HISTORIC AND DESIGN REVIEW COMMISSION

Agenda Item No: 17

HDRC CASE NO: 2015-447
ADDRESS: 2510 KENNEDY CIRCLE
LEGAL DESCRIPTION: NCB 10879 BLK 13 LOT 1 (BCB UT-20A & 20D)
ZONING: C3 H
CITY COUNCIL DIST.: 3
DISTRICT: Brooks School of Aerospace Medicine Historic District
APPLICANT: Ignacio Rodriguez/McChesney Bianco Architecture
OWNER: University of Incarnate Word
TYPE OF WORK: Exterior modifications
REQUEST:

School of Osteopathic Medicine
Building 150 Renovations – Phase I
University of the Incarnate Word
2510 Kennedy Circle
San Antonio, TX 78235

5.0001 NEW CONSTRUCTION - EXISTING BUILDING SOUTH EXTERIOR ELEVATION "A"

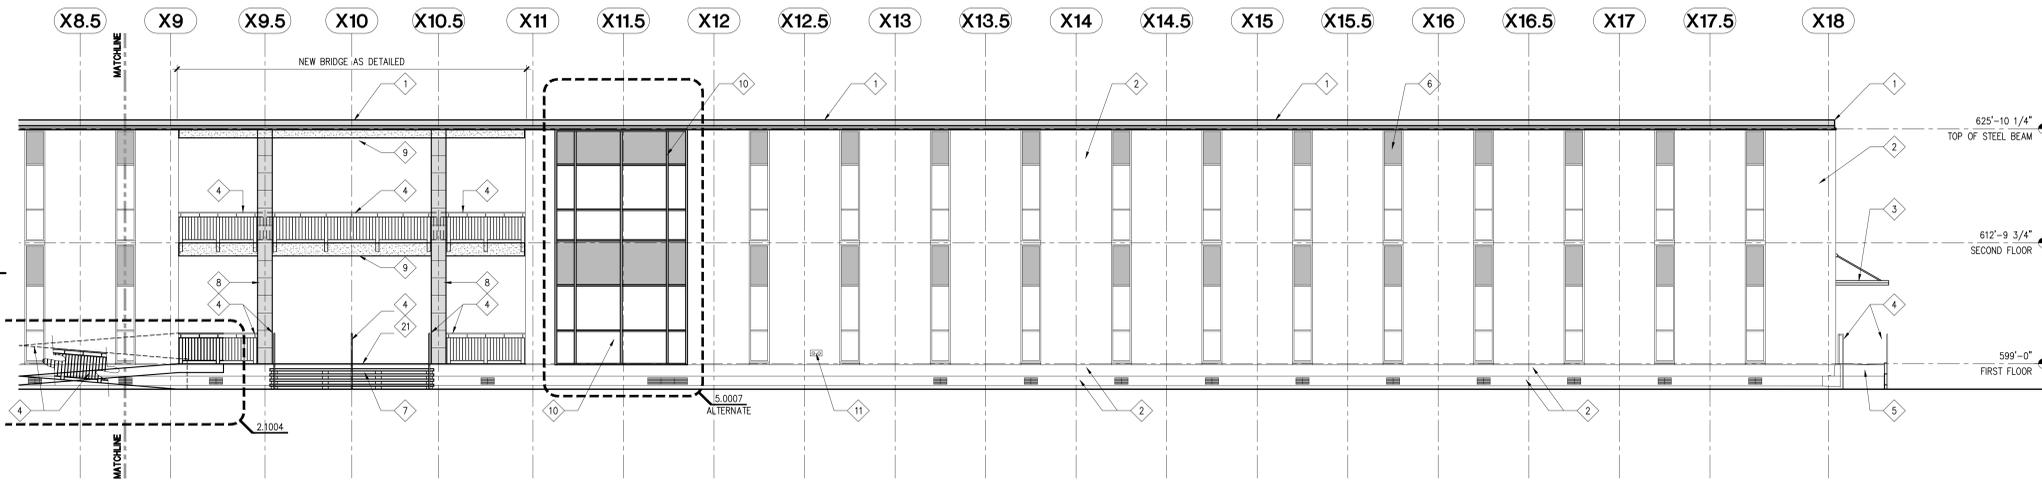
- b. The applicant is proposing to create a new entry on the southern facade. According to the Guidelines, historic doors and windows must be preserved. In the Design Guidelines for the School of Aerospace Medicine Historic District, the northern facade is a significant, primary facade and should not be altered, while the southern facade minor modifications are allowed. Staff finds the new entry appropriate and consistent with both the Design Guidelines for the School of Aerospace Medicine Historic District and the Historic Design Guidelines.

Staff recommends approval of items #1 through #4 based on findings a through e.

5.0003 NEW CONSTRUCTION - EXISTING BUILDING WEST EXTERIOR ELEVATION

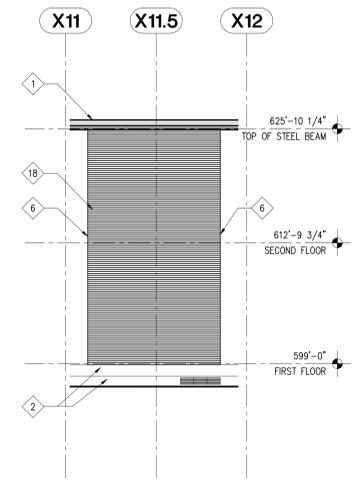
- f. The applicant is proposing to create new window openings on the east and west facades. According to Design Guidelines and Master Plan for the School of Aerospace Medicine Historic District, 5.C.2.g, a strong presence of masonry in these buildings is important to maintain. The windows proposed in the brick side facades are identical to the windows on the north and south facades. The School of Aerospace Guidelines state that new windows should be differentiated from the originals. Staff does not find the east and west façade proposals consistent with the Guidelines, nor appropriate as they potentially present a false sense of history.

Staff does not recommend approval of item #5 based on findings f.

5.0101 NEW CONSTRUCTION - EXISTING BUILDING NORTH EXTERIOR ELEVATION 'A'

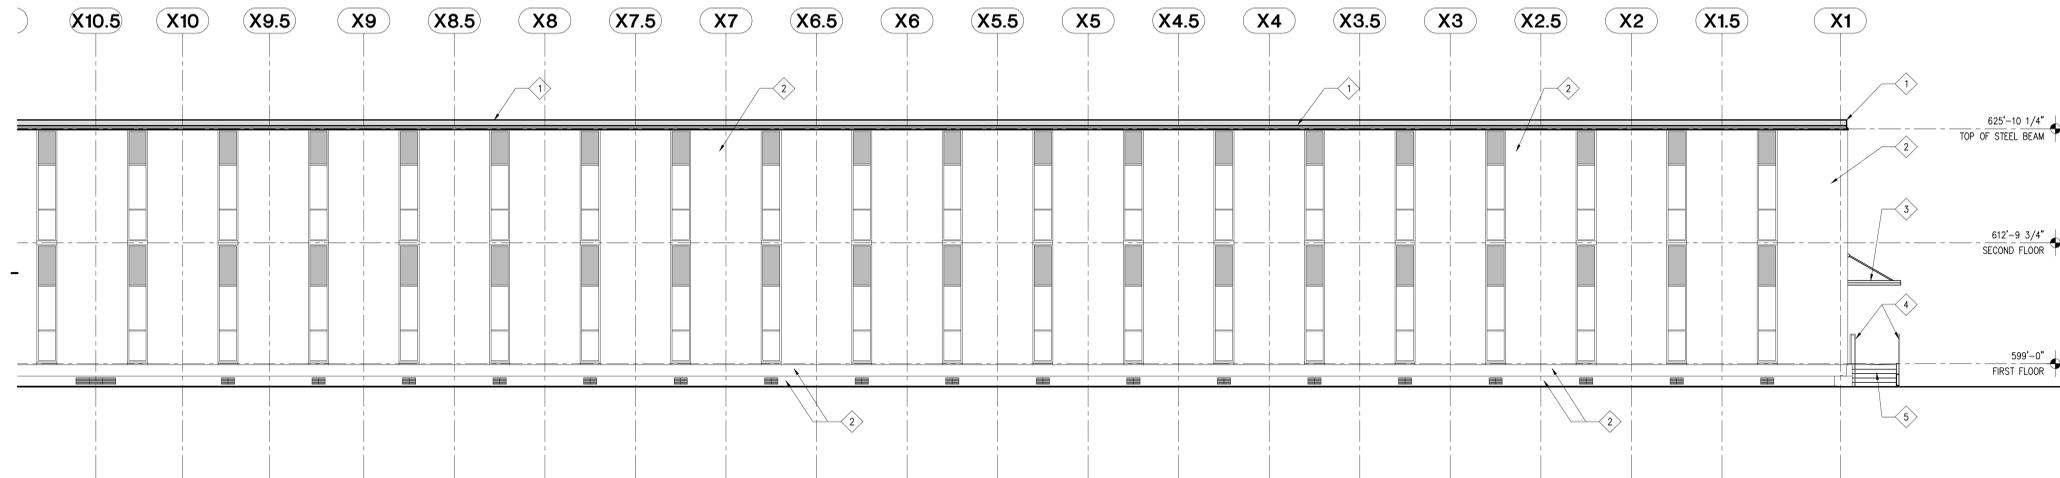
- e. The applicant is proposing to install new exterior lighting on the north facade just below the roofline. According to the Guidelines, lighting should be placed in locations that are unobtrusive in design, and that do not distract from
